09/27/2024  
CAL FTL 35-002

**Subject: Z-Bracket Welded too High on Rear Axle Differential Housing**

**Model: New Cascadia**

**Build Date Range: Selected Vehicles Built Between January 1, 2023, and August 5, 2024**

**Fig. 1 High-Welded Z-Bracket Causing 5th Wheel Contact**

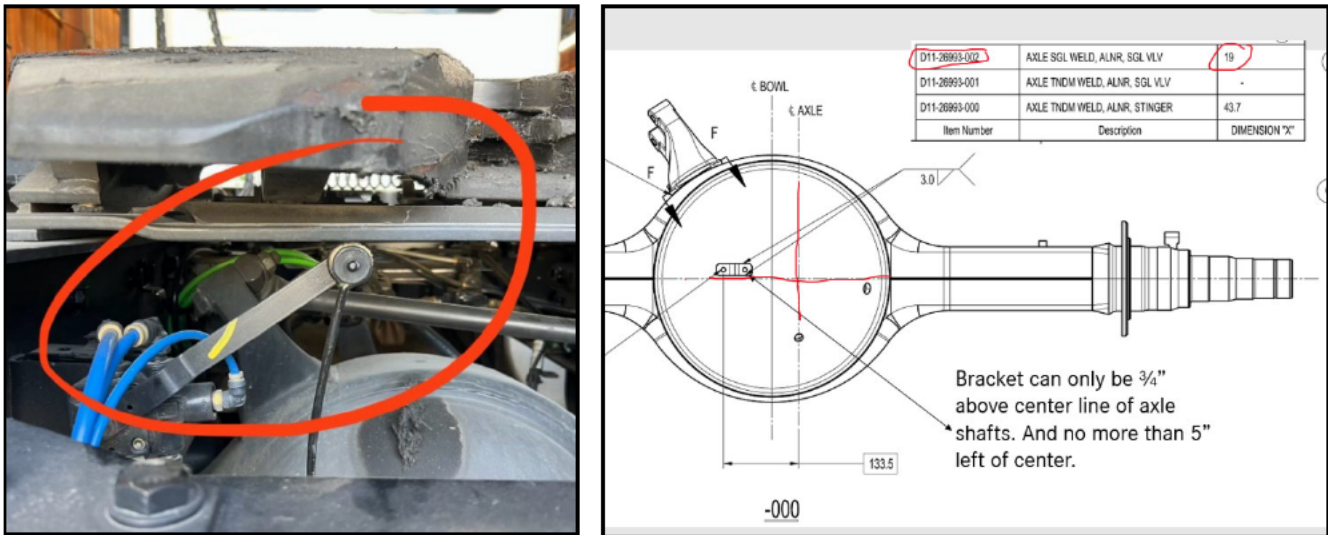
After finding one vehicle Z-bracket welded too high on the rear axle differential housing causing linkage to contact bottom of the 5th wheel slide plate, DTNA has taken a proactive approach to assess if other vehicles may have the same issue. With the following inspection, the vehicles will be surveyed to collect more evidence. Vehicles produced at the Saltillo production facility from January 1, 2023, to August 5, 2024, should be inspected for the following.

### Leveling Valve Bracket – VA8797

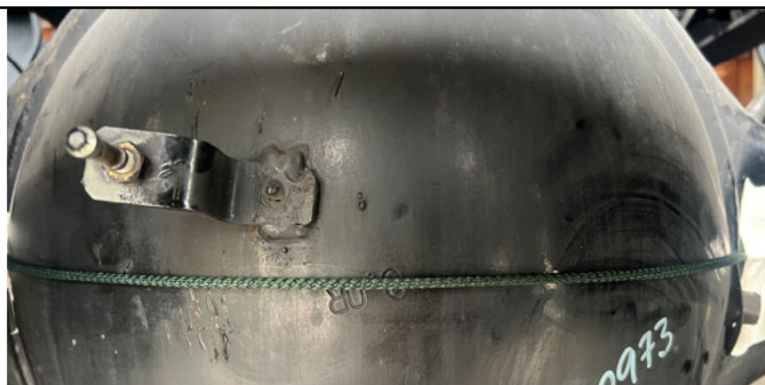
**Fig. 2 Before Fix**

**Fig. 3 After Fix**

Fig. 4 Drawing D11-26993

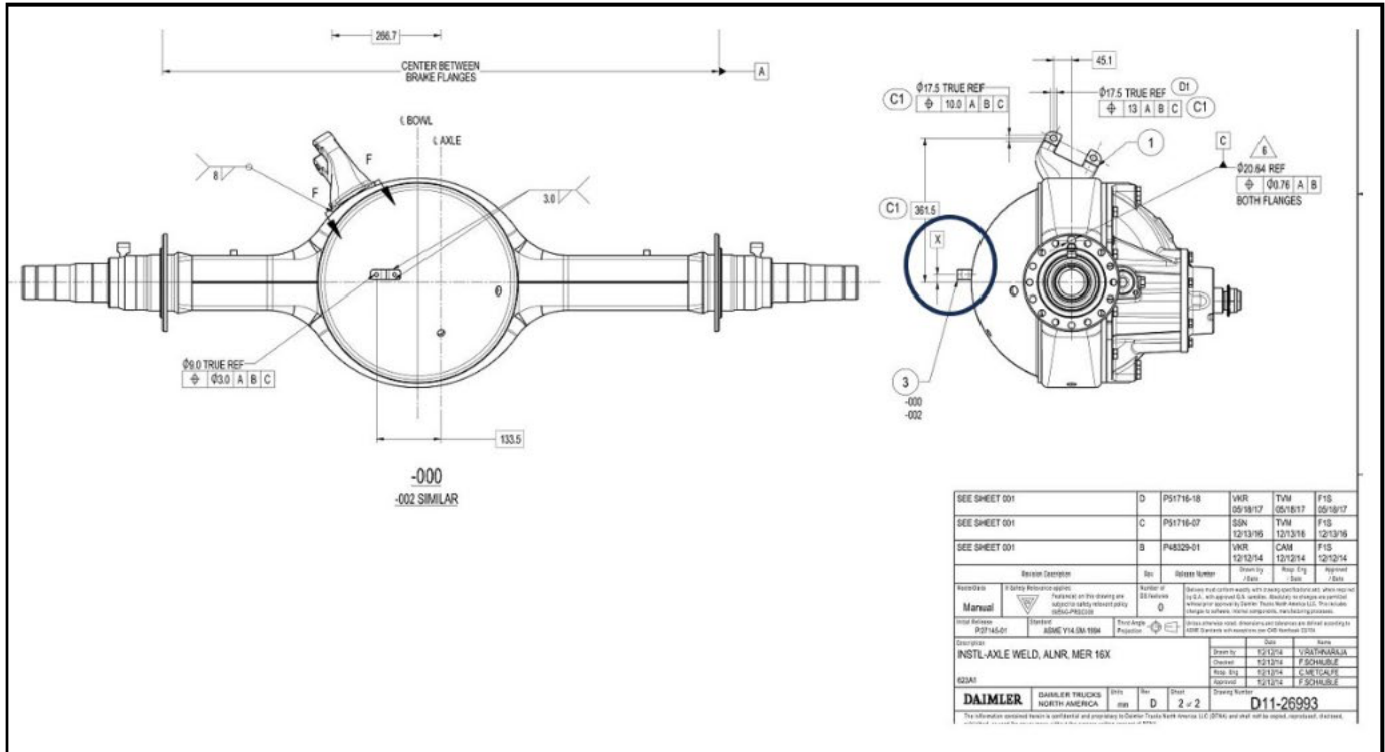
1. Park the vehicle, shut down the engine, and apply the parking brakes. Chock the tires.
2. Locate the Z-bracket on the rear axle of the suspect trucks identified on the VIN list.
3. Use the drawing D11-26993 to verify the correct location.
